**From:** [Murray, Susie](#)  
**To:** [TREVOR HAM](#); [Gurney, Cleve](#)  
**Subject:** RE: [EXTERNAL] 1801 Ridley Ave. Family Apartments  
**Date:** Friday, October 14, 2022 1:14:00 PM  
**Attachments:** [24\) Landsape and Lighting-057 CP-IPLA.pdf](#)

**From:** TREVOR HAM <only1remy@yahoo.com>  
**Sent:** Wednesday, October 5, 2022 5:53 PM  
**To:** Murray, Susie <SMurray@srcity.org>  
**Subject:** [EXTERNAL] 1801 Ridley Ave. Family Apartments

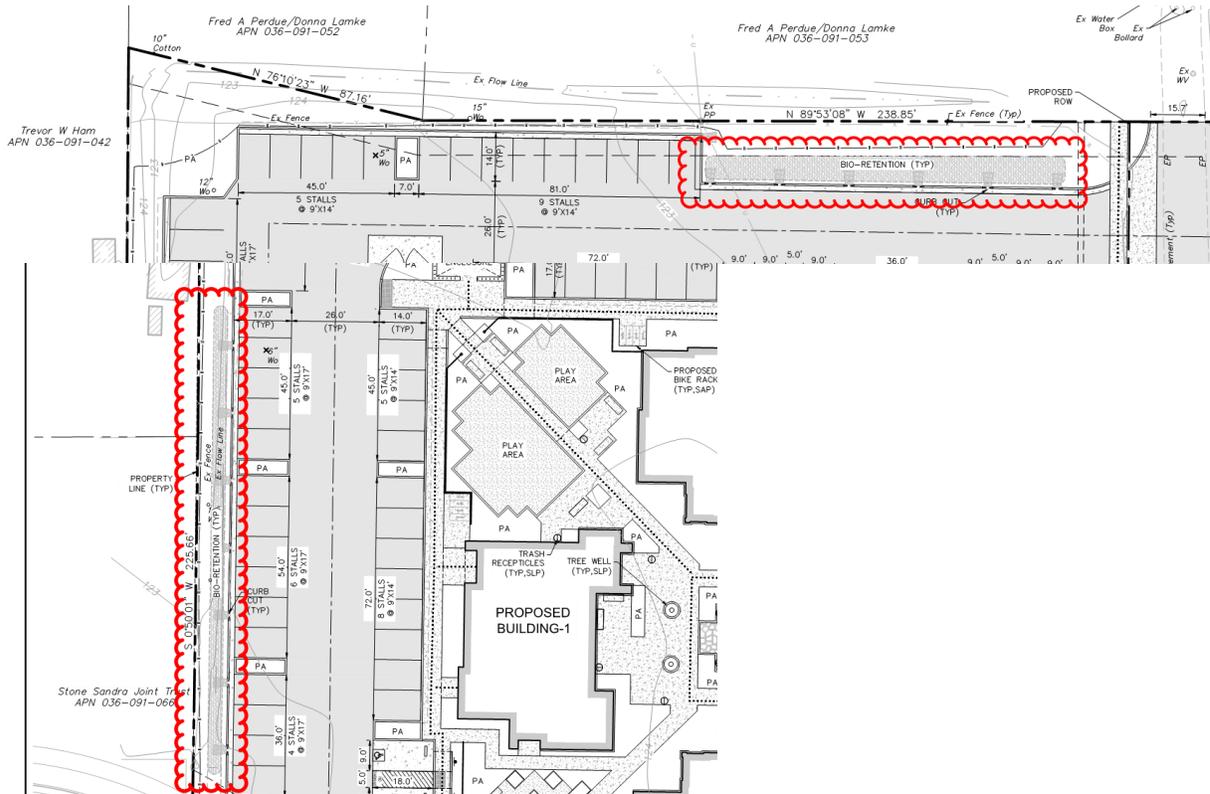
Last time this project was proposed the dumpster area was located in my corner out of site. I've lived in apartments and know that they smell and are often over filled, maybe put them on Ridley or put them in an out building. The trash enclosure is proposed in the northwest corner of the site, and is separated from your property by the parking area. The project will be conditioned appropriately to ensure that the enclosure is not a nuisance and the trash pick up will be done at a reasonable hour, after 8:00 am, given its proximity to existing residential uses.

My main concern is noise followed by security and I would hope that the Soundwall (not a wood fence) would be 8 feet tall or 6 with lattice of some sort. I'm not sure at this point whether it will be a wall or a fence; but I can assure you there will be separation between your property and the new development.

## RIDLEY TYPICAL SECTION (NORTH)

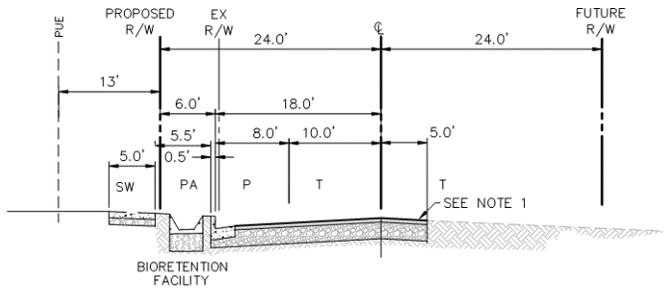
Will Ridley Rd. be widened ? I've seen fire trucks and ambulances get blocked from the rugby field at Comstock

Ridley Ave will be improved to a minor street standard along the project frontage (half street width improvements consist of a 10' travel lane, 8' parking lane, 6' planter strip, and 5' sidewalk).

1. A COMPLETE 20' ALL WEATHER WIDTH IS REQUIRED ALONG PROJECT FRONTAGE FOR THE MOST NORTHERLY 200'±LF OF RIDLEY AVE.
